Vintage Denim Ltd. (Extension)

13 November 2023

Structural Inspection Report

Observation-1: Inconsistencies between software output and design report. (Fabric Store Shed)

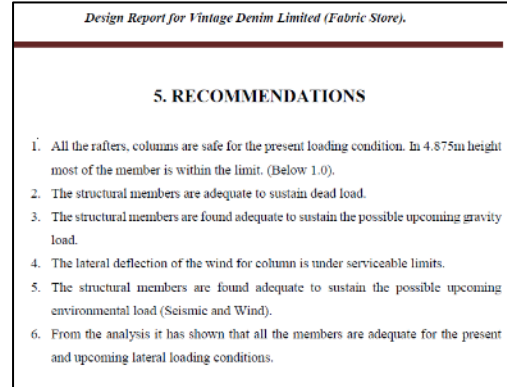
The stress ratio for steel rafters is more than 1.0 in the software analysis.

Declared as safe in the recommendation of design report.

Lack of lateral load transfer media in eave & ridge

Description: As per the software output, stress ratio for steel rafters is more than 1.0 (unsafe) but in the design report stress ratio for those members is declared less than 1 (safe). Also, improper connections and lack of lateral load transfer media along eave & ridge was observed on-site which has not been considered in the software based structural analysis. In addition,

Item No.	Observation	Action Plan	Timeline
1.	Inconsistencies between software output and design report. (Fabric Store Shed)	The building engineer is required to revise the design report based on in-situ material strength & software-based analysis and submit the documents to RSC for review.	within 6 weeks

2.	Inconsistencies between software output and design report. (Fabric Store Shed)	Carry out suggested remedial works if required.	within 6 months
3.	Mismatch between drawing & on-site condition. (Fabric Store Shed)	The building engineer is required to survey the full structure and produce accurate as-built drawings.	within 6 weeks
